January 26th, 2017  
Peru State College, Theatre and Event Center Renovation and Addition  
Peru, Nebraska

-----  
**ADDENDUM**

**1 PARTIAL DEMO PLAN - MECH 103**

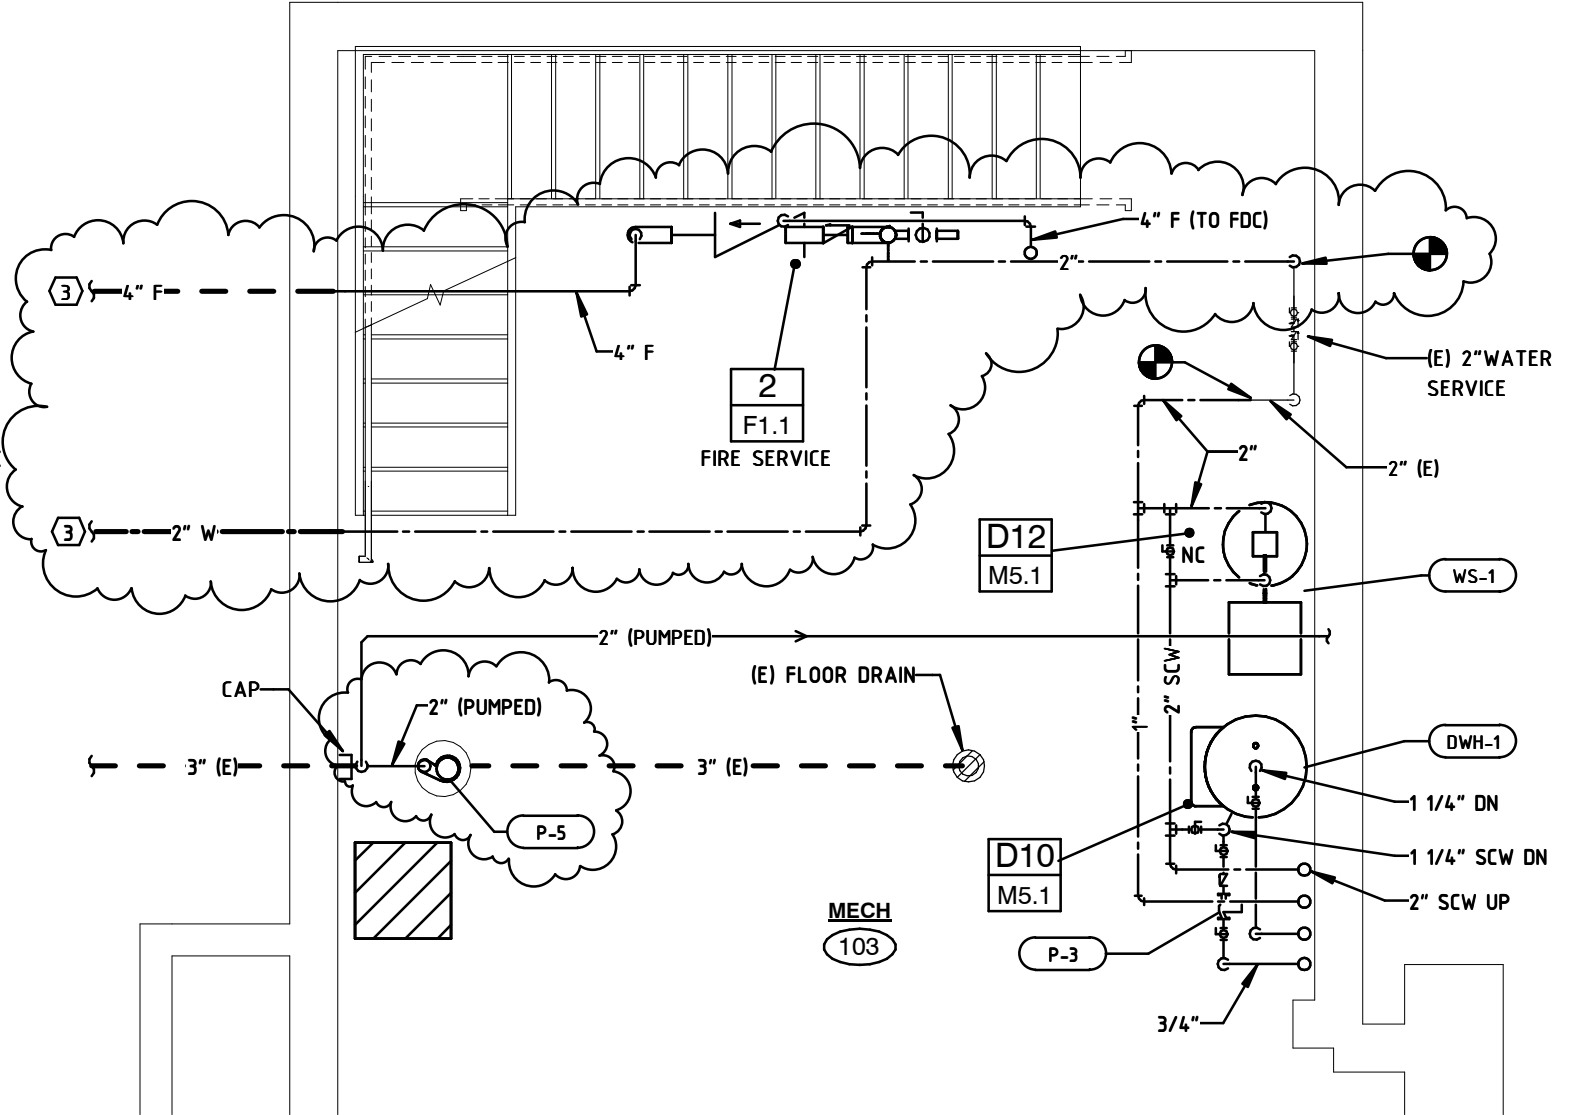
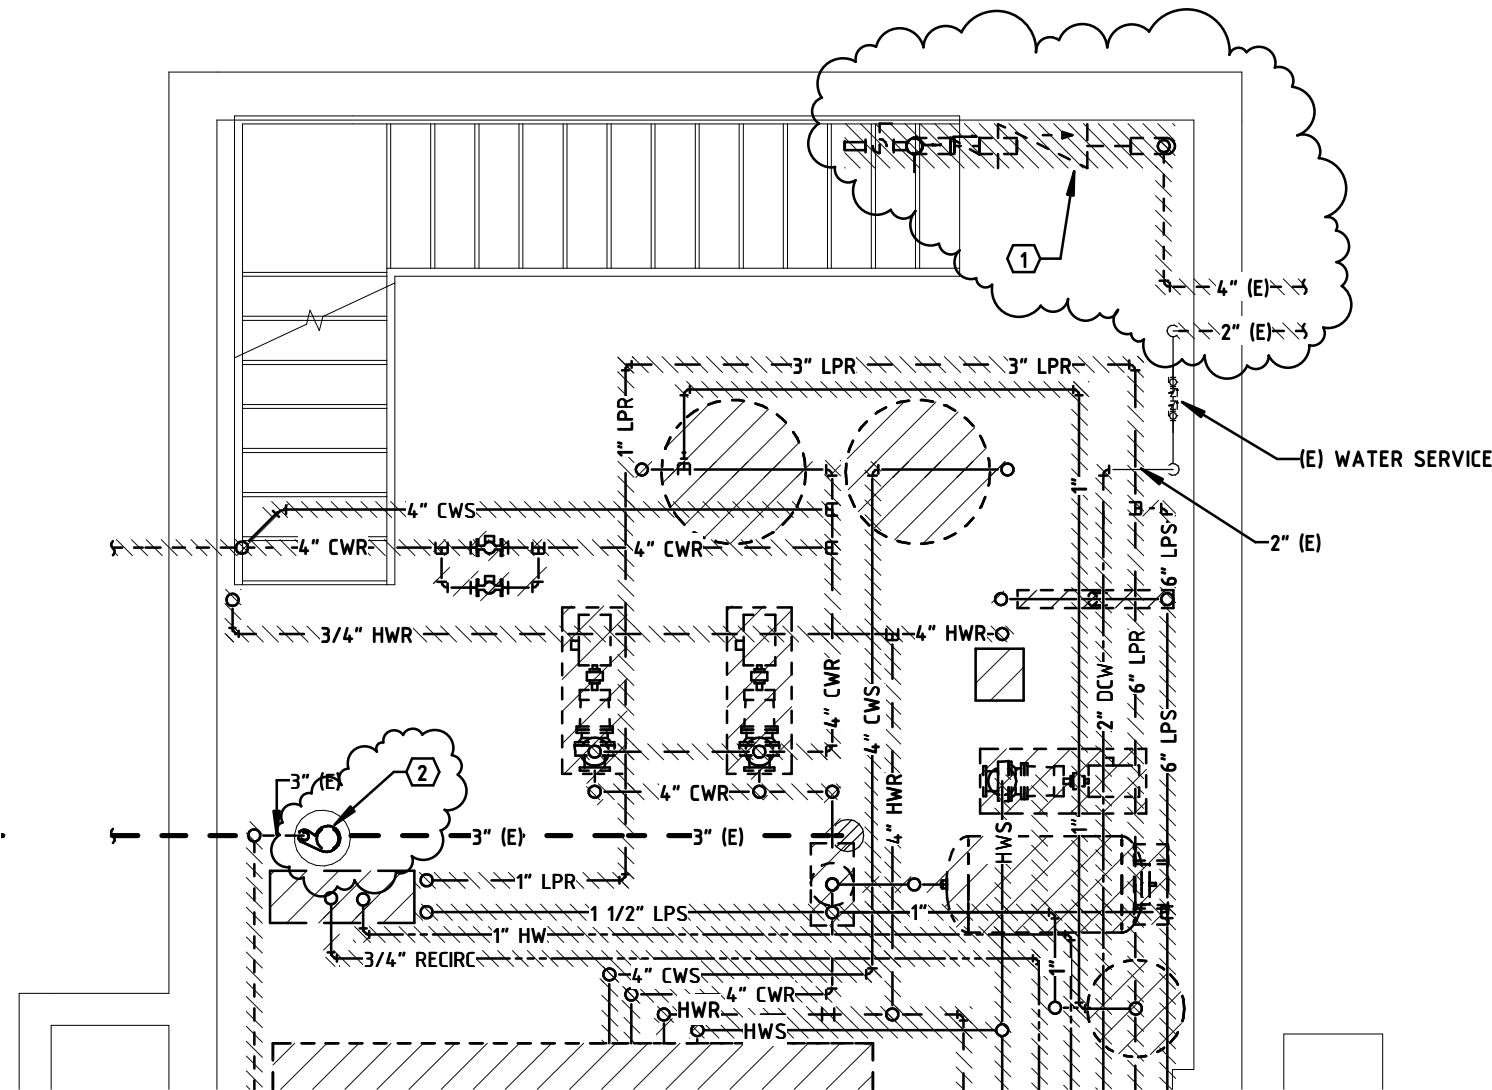
- 2) Remove existing fire service entrance and associated piping and accessories. See attached sheet M1 for more information.
- 3) Remove existing sump pump, pump to be replaced. See attached sheet M1 for more information.

# 1 PARTIAL PLUMBING PLAN - 117

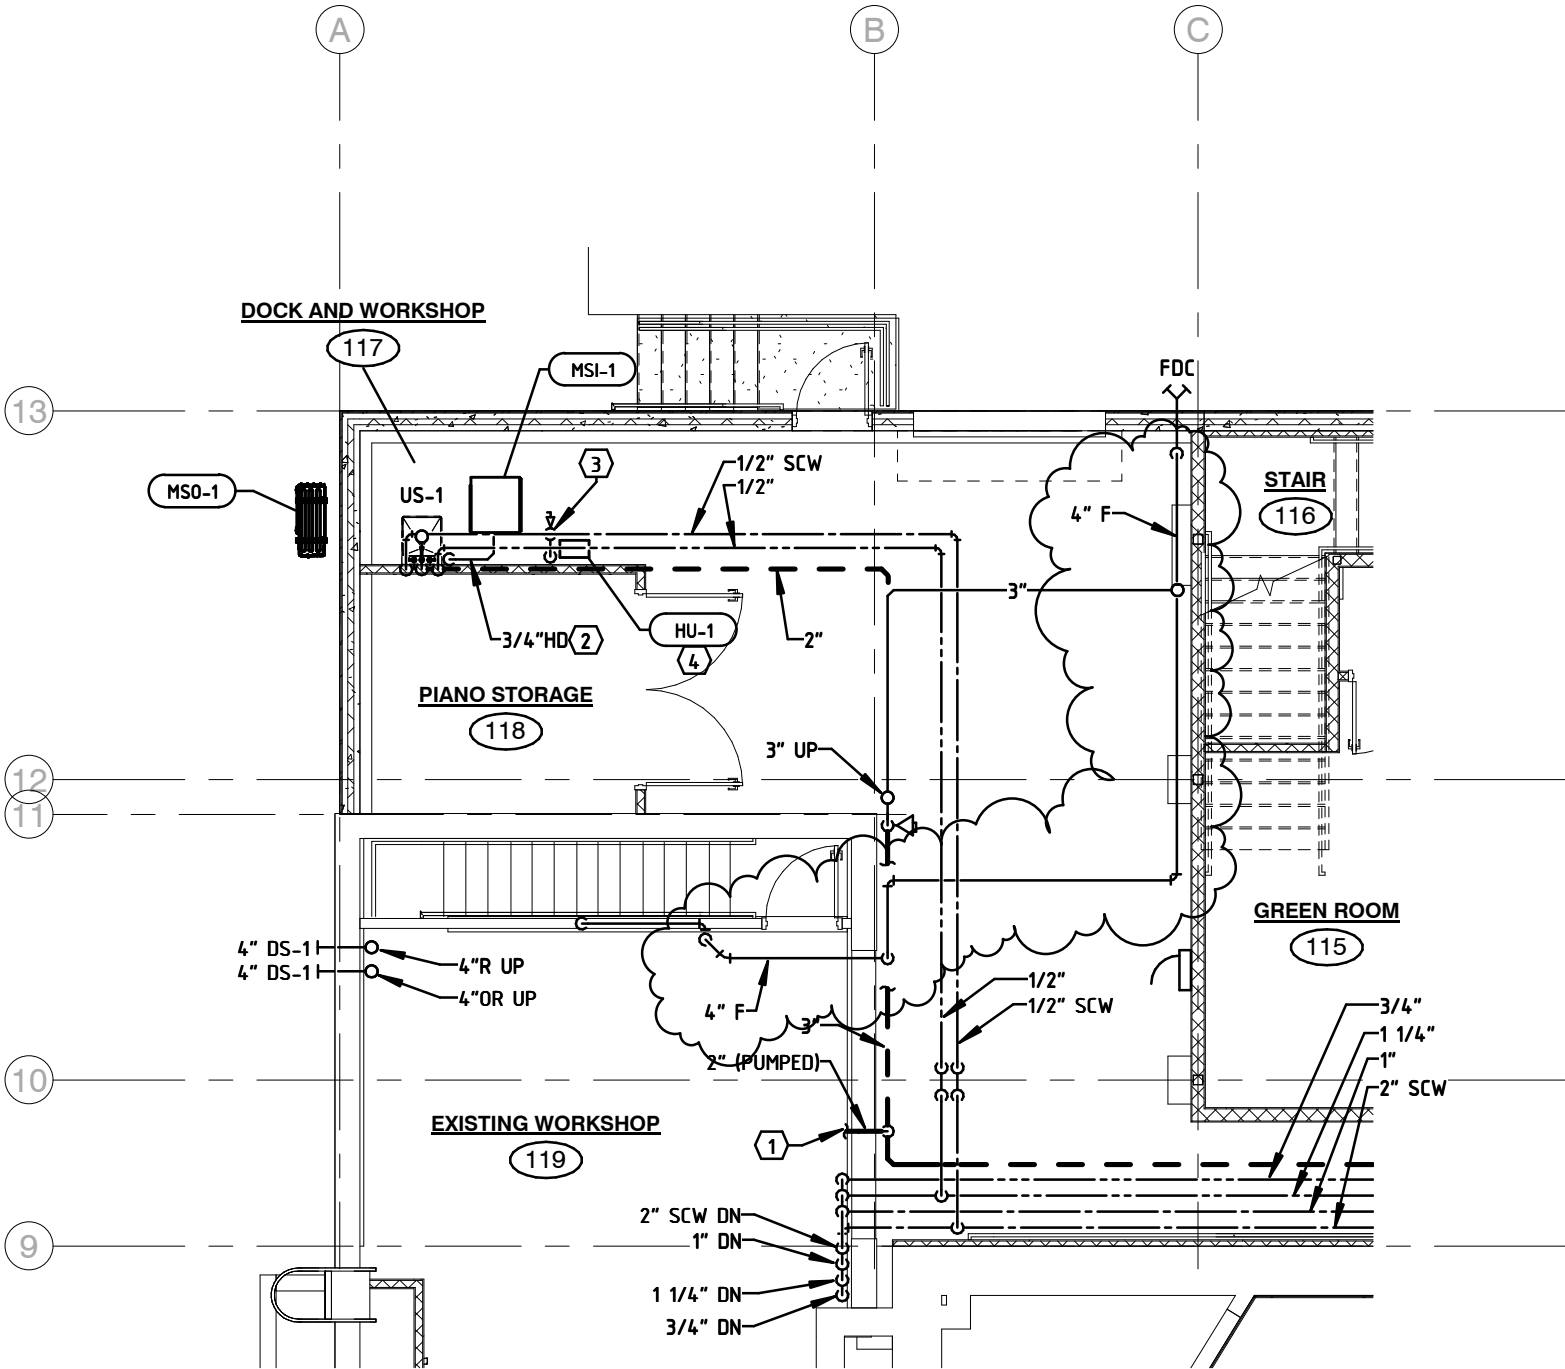
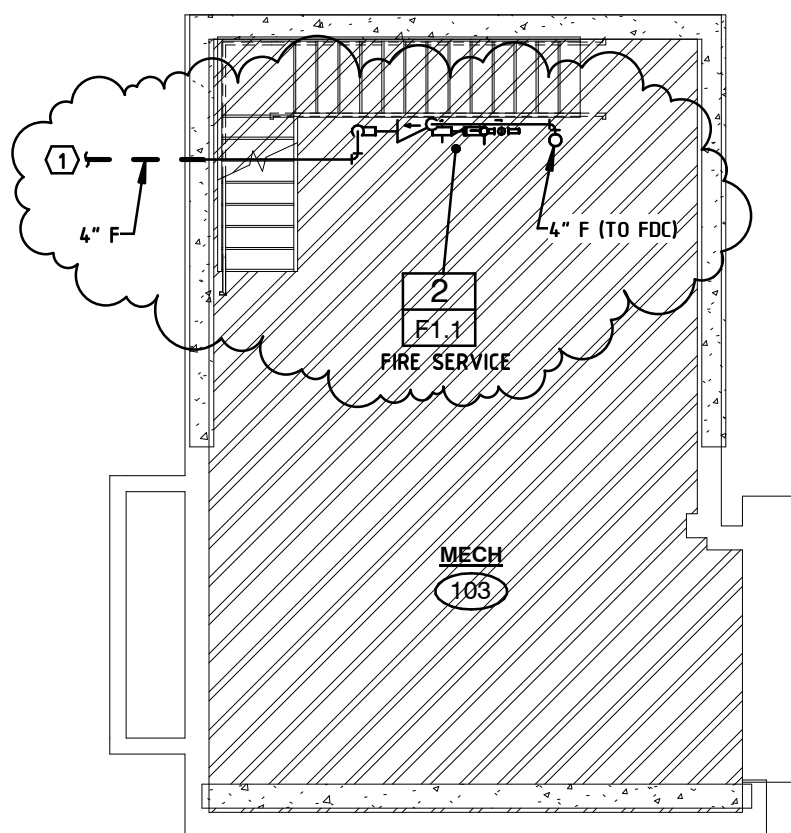
- 1) Deleted 2"W and 4"F service piping running below slab of 117 from exterior of building to basement.
- 2) Revised routing of 4"F piping to FDC to run overhead in 117 as shown on attached sheet M1.1.

**2 NFPA 13 FIRE SERVICE ENTRANCE DETAIL**

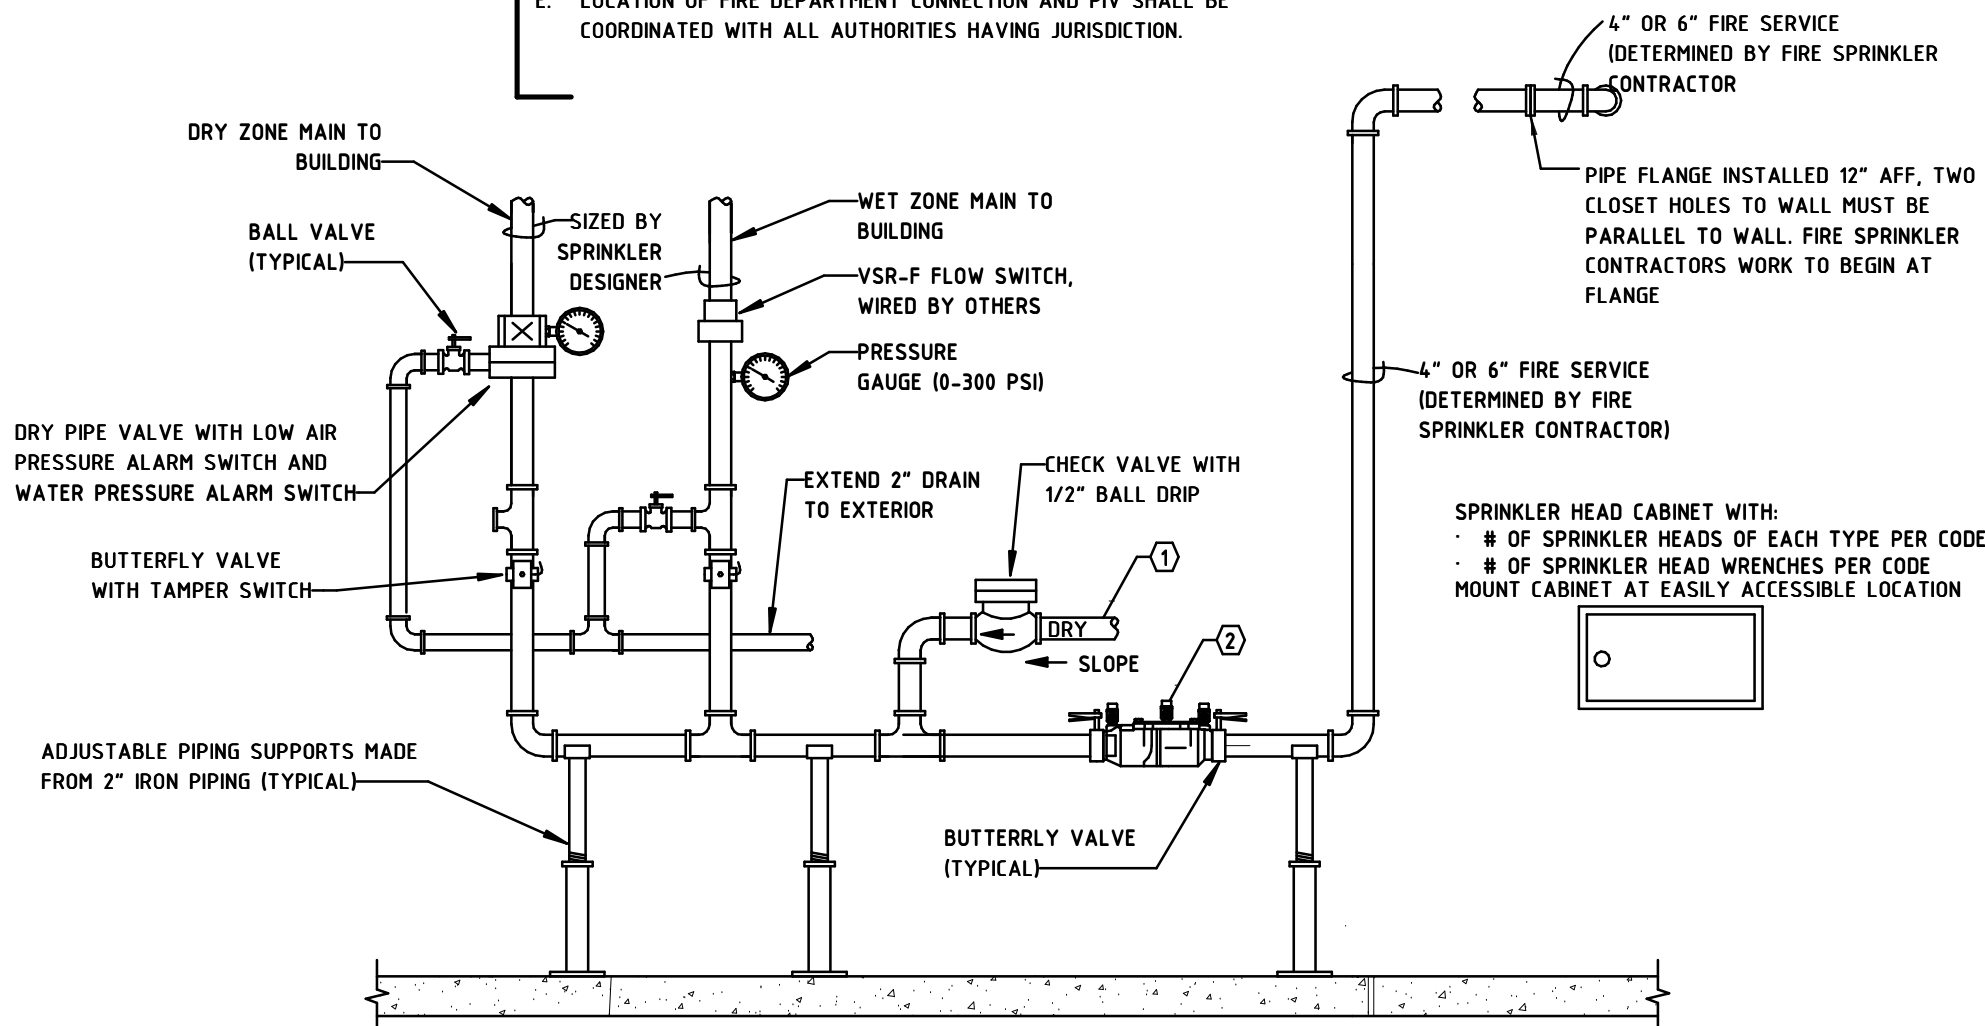
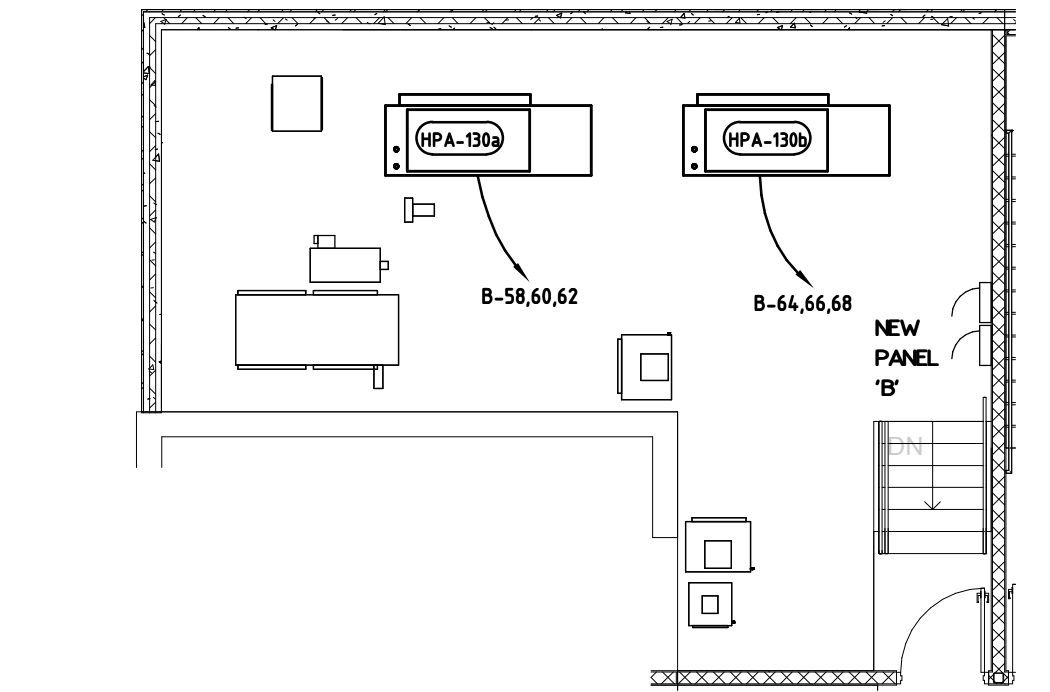
- 1) Install new Fire Service Entrance in Mech-103, extend service piping and piping to FDC as shown on attached sheet F1.1.
- 2) Added "NFPA 13 Fire Service Entrance Detail".
